STAFF REPORT
(One-Step Final Plat)

CASE NUMBER: SUB 2005-24 -- TIMBER LAKES ESTATES 4TH ADDITION

STAFF REPORT
(One-Step Final Plat)

VICINITY MAP

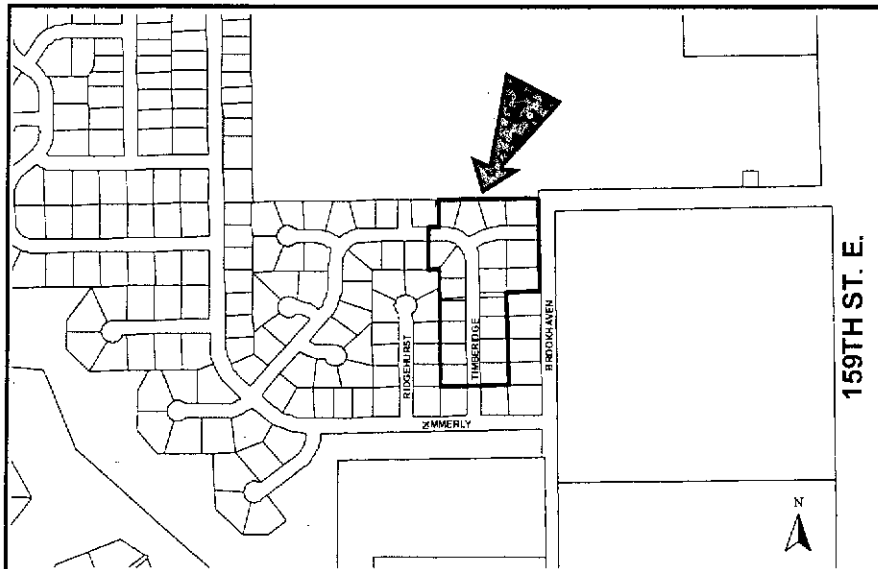
- E. The vicinity map needs to be corrected.
- F. The Applicant has platted a 20-ft building setback along Timberidge Circle which represents an adjustment of the Zoning Code standard of 25 feet for the SF-5, Single-Family District. The Subdivision Regulations permit the setback provisions to be modified by the plat upon the approval of the Planning Commission.

VICINITY MAP

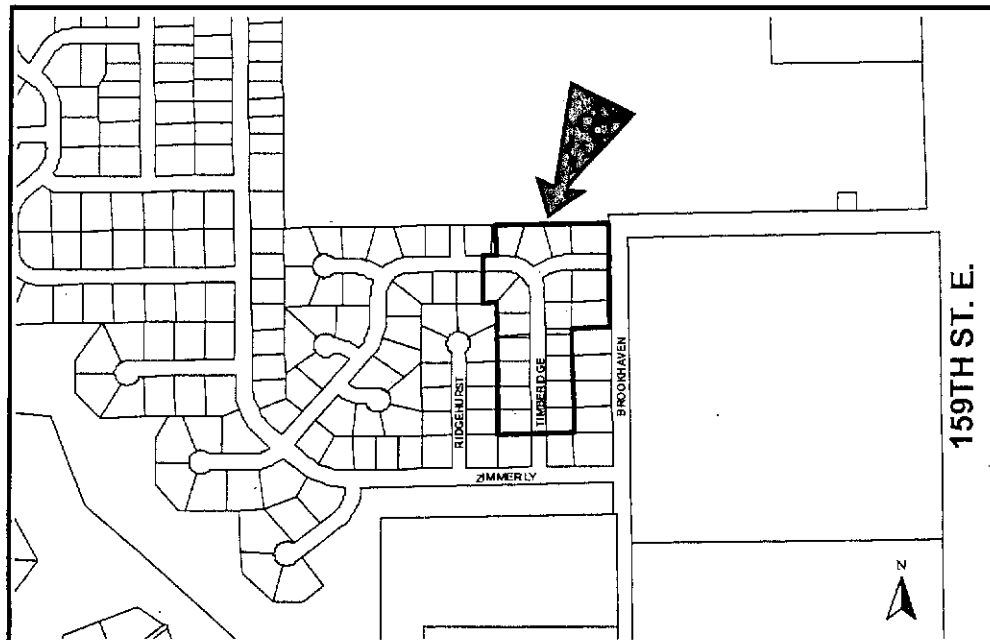
- E. The section, township and range in title block need to be corrected or deleted.
- F. The vicinity map needs to be corrected.
- G. The plat's text shall include reference to "Lots, blocks and a street" in the owner's certificate.
